SUBJECT: ATM Vibration and Acoustics
Measurements - Case 620

DATE: December 27, 1967

FROM: S. H. Levine

ABSTRACT

FIGURE 1 - ATM LAUNCH TELEMETRY

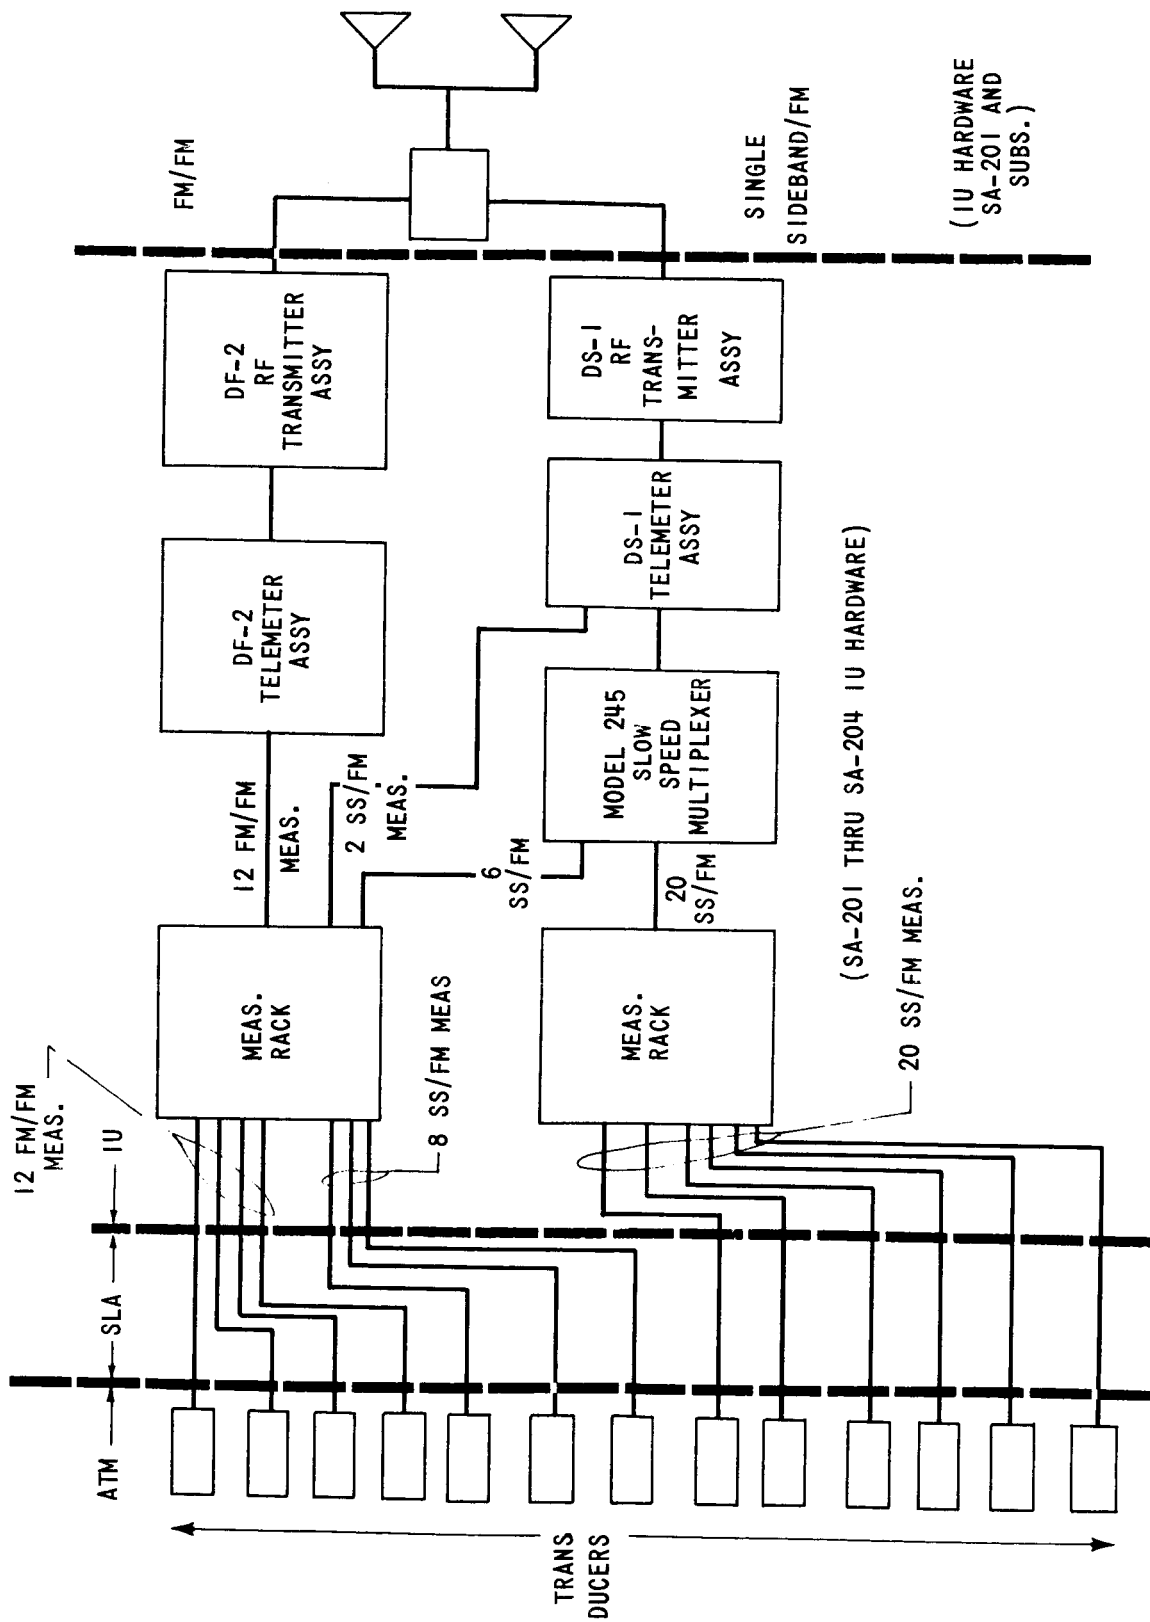
The current AAP program baseline (Ref. 2) provides that hardware will be carried in the AAP-4 Instrument Unit (IU), which will perform the task of transmitting these real time ATM measurements during launch phase of AAP-4 flight. Figure 1 identifies the hardware which currently constitutes the MSFC hardware baseline for this function. Selection of the F-2 Telemetry System (FM/FM telemetry) and the S-1 Telemetry System (Single Sideband/FM telemetry) along with the necessary telemetry support hardware, identified below, was predicated on the basis of the following rationale:

Since the ATM active cooling system is located on the Experiment Package, the telemetry units, previously identified, would have to be mounted on the Experiment Package where cold plates could be made available for cooling them. Location of these units in or on the ATM Experiment Package could present the following problems:

1. The need for additional wiring across the ATM gimbals to transducers on the rack and to power sources on the rack.

2. The requirement for additional ATM power during launch and docking phases. Currently, the only power available on the ATM prior to docking of the LM/ATM to the MDA (after which solar array deployment occurs) comes from Silver-Zinc primary (non-rechargeable) batteries (Ref. 5) which are specifically used for ATM Rack thermal control during this period. All other ATM systems, including the ATM solar array rechargeable battery electrical power system, in the current planning, will not be energized until after deployment of the ATM solar array. The requirement for the ATM coolant system to be active during the docking phase of the mission would probably require either a growth in the primary batteries or activation of the Nickel-Cadmium rechargeable batteries prior to solar array deployment.

3. The possible interference with experiment thermal control by locating this telemetry equipment between the experiments and the thermal sink (canister wall).

4. The addition of new antennas to permit transmission to the MSFN prior to solar array deployment or a scheme to permit utilization of existing ATM antennas (presently located on the extremities of the solar wings).

5. The possible impact on design of the ATM gimbal mounts, gimbal torquers, and roll positioning devices. Gimbal mounts are currently being designed by Perkin-Elmer for an Experiment Package weight of 5000 $\pm 10\%$ pounds. The current weight estimate of the Experiment Package is approximately 5400 pounds. Utilizing this telemetry approach would leave no margin for design contingencies.

6. The addition of equipment to the canister would reduce the available space between experiments and would therefore restrict factory and MSOE activities within the experiment package.

If the alternate MSFC approach of mounting the required telemetry equipment, for this function, on the ATM Rack is adopted, either:

1. The Up-rated Saturn I hardware would have to be significantly modified to operate in a passively controlled thermal environment or
2. the utilization of other hardware would have to be considered. This, of course, would not permit MSFC to benefit from its experience with Saturn hardware, vendors, etc., and would necessitate additional effort on contracts, specifications, etc.

At best, either ATM Rack mounted system would require some hardware development and qualification work and would carry along with it the power and antenna complications previously cited for the Experiment Package mounted system. Incorporation of these units on the ATM Rack does not appear to result in either a space problem or an accessibility problem, since the rack has recently been lengthened and the electrical power system's battery - charger - regulator units have been decreased in number (i.e., more space is available).
